SUPPLEMENTAL RESPONSE TO REQUEST FOR ADDITIONAL INFORMATION

APR1400 Design Certification

RAI No.: 160-8174

SRP Section: 09.03.04 – Chemical and Volume Control System (PWR) (Including Boron Recovery System)

Figure 9.3.4-1 Chemical and Volume Control System Flow Diagram (1 of 7)

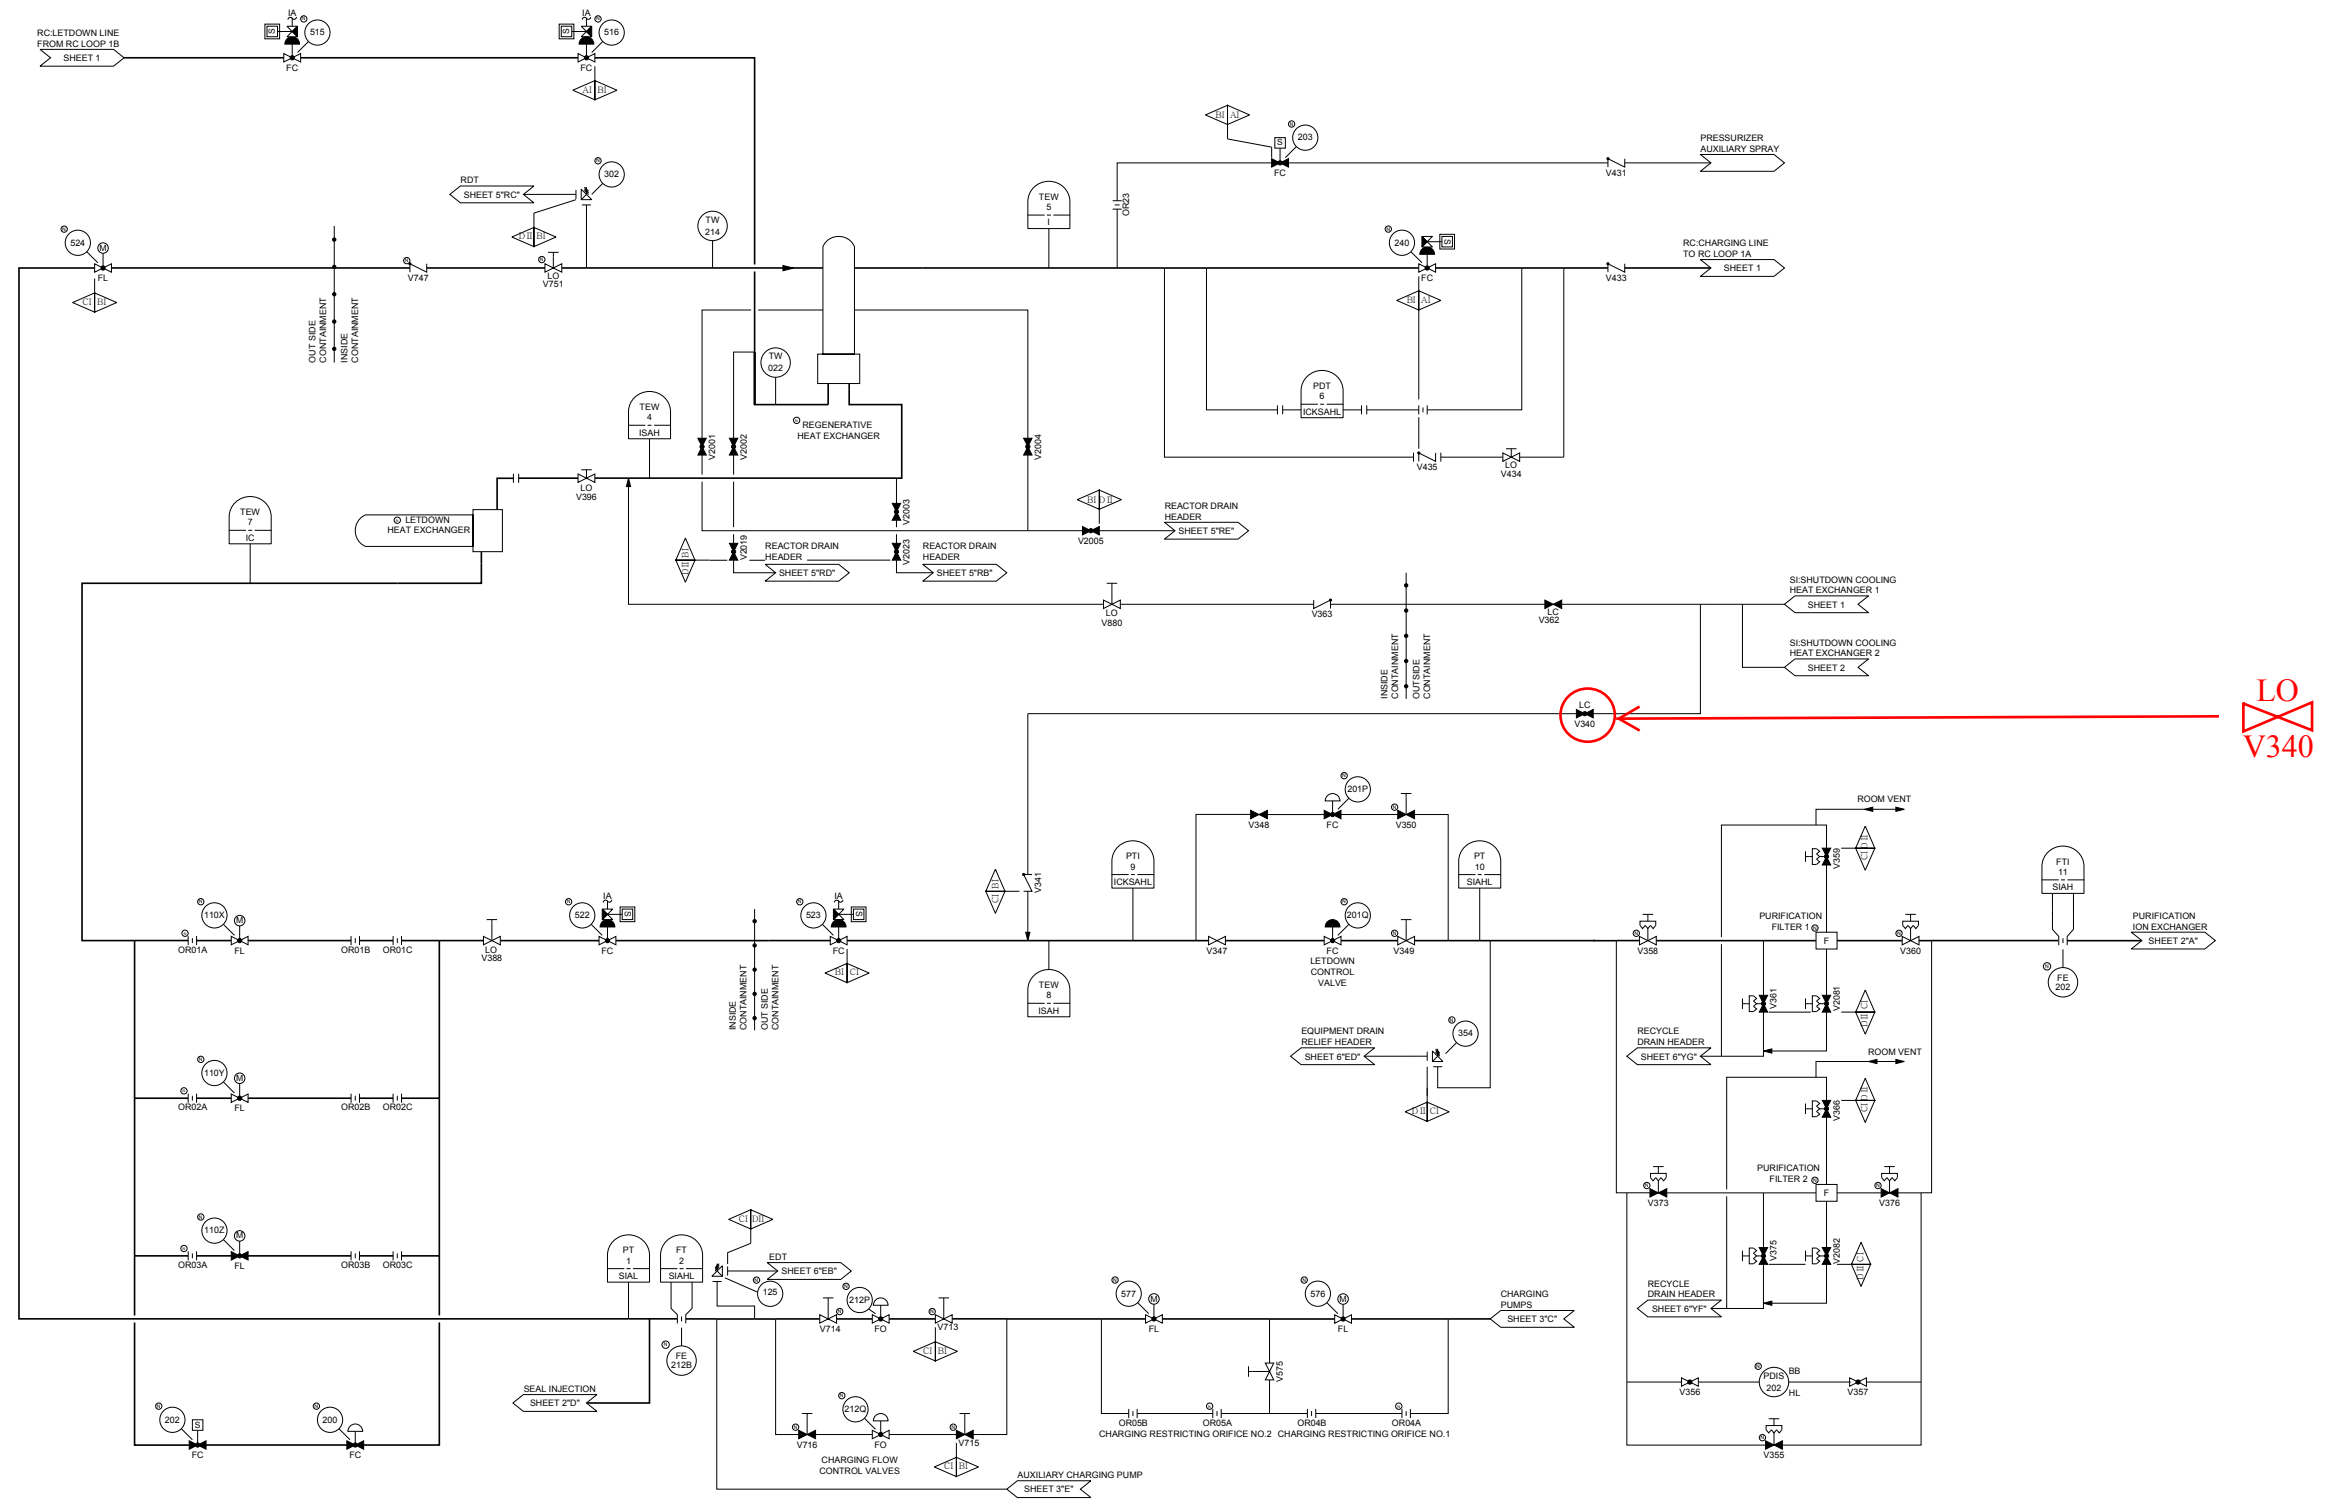
In regards to the applicant's response to RAI 160-8174, Question 09.03.04-6, the applicant provided a satisfactory response regarding updating Tier 1 to be consistent with Tier 2 for valve CV-362. During the staff's review of the Attachment to Question 09.03.04-6, the staff noted that CV-340 of DCD Tier 1, Figure 2.4.6-1 is also inconsistent with DCD Tier 2, Figure 9.3.4-1. The staff would like to discuss with the applicant a means for correcting this inconsistency and determining if other inconsistencies like this are in the applicant's DCD.

CV-340 is a normally open valve. DCD Tier 2, Figure 9.3.4-1 (Sheet 1 of 7) will be revised as shown in Attachment 1. But because CV-340 is not subject to CVCS ITAAC (not included in DCD Tier 1, Table 2.4.6-2), the detailed information on the valve such as the locking status does not need to be shown in DCD Tier 1, Figure 2.4.6-1.
